## **Document 12/132b: Annex 3 to ComReg Document 12/132**

### **Aegis Systems Limited and Plum Consulting Response Document**

**Aegis Systems Ltd. and Plum  
Consulting's responses to the  
comments received from  
interested parties in response  
to 11/80a on the future of the  
2.6 GHz radio spectrum band**

**2302/MMDS-FW/FR/V1**

**Figure 32: Variation of Separation Distance with NFD (Digital/Analogue MMDS Transmitter Interference into NGMB BS Receiver)**

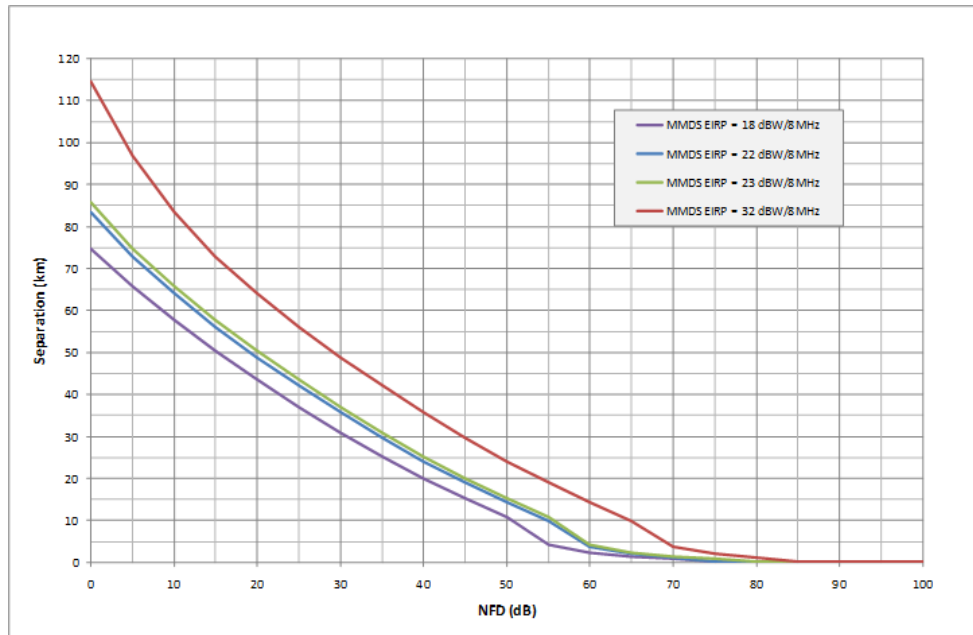
**However they then go on to perform a prediction with an assumed NFD of 30 dB and an MMDS EIRP of 32 dBW / 8 MHz where the required separation is 33 km. There is no explanation as to why the NFD should be 30 dB and again have used the analogue maximum EIRP. This simply has the effect of increasing the required separation.”**

In Document 11/80a on page 60 Figure 32 shows the results for a set of MMDS EIRP values as shown below so the conclusions are not based on the MMDS analogue EIRP.

As mentioned earlier in this document the main conclusions of Document 11/80a are based on an MMDS EIRP level of 18 dBW / 8 MHz which represents 17 out of 22 MMDS transmitters.

Once more it is worth noting that the adjacent channel sharing is not feasible due to the MMDS channel plans that are based on the use of all channels at MMDS sites. Furthermore, the co-existence is determined by the ‘MMDS transmitter into NGMB base station receiver’ **co-channel** interference scenario.

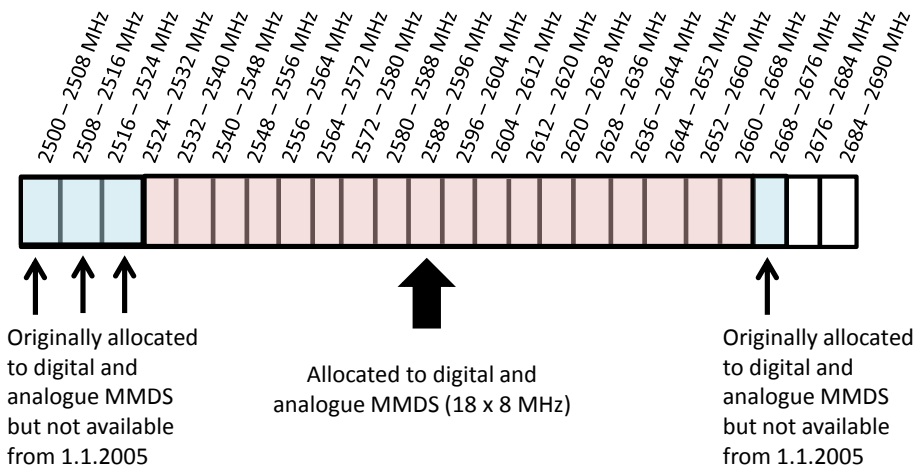
***analysis carried out by Aegis and Plum on the possibility of spectrum sharing in the 2.6 GHz band greatly overstates the possibility of interference between MMDS and NGMB services under each of the scenarios examined. As we have shown, Aegis and Plum’s analysis utilises a number of erroneous base assumptions (in particular in the way different EIRP levels are used) which means that predicted output figures (in particular in relation to separation distances) are greatly overstated.***

***In addition, Aegis and Plum appear to have taken no account of the possible co-existence of MMDS and NGMB where the latter is deployed to provide additional in-building capacity using micro and pico cells. Indeed, Aegis and Plum do not appear to have taken sufficient (or, indeed, any) account of demand drivers for mobile broadband spectrum more generally and what mobile operators’ strategies in this regard is likely to mean for the demand for 2.6 GHz spectrum to support NGMB services between now and 2019. This is an issue we now discuss in more detail as we consider issues relating to the economic analysis that is contained in the Aegis and Plum report.”***

The points raised by UPC Communications (Ireland) Ltd. in their conclusions on Document 11/80a replicate those already responded to in this document.

It is important to realise, as noted in the individual responses to UPC Communications (Ireland) Ltd’s comments above, that there is no potential for adjacent channel sharing between MMDS and NGMB as the MMDS deployments utilise the majority of the 2.6 GHz band as shown in the figure below, taken from Document 11/80a:
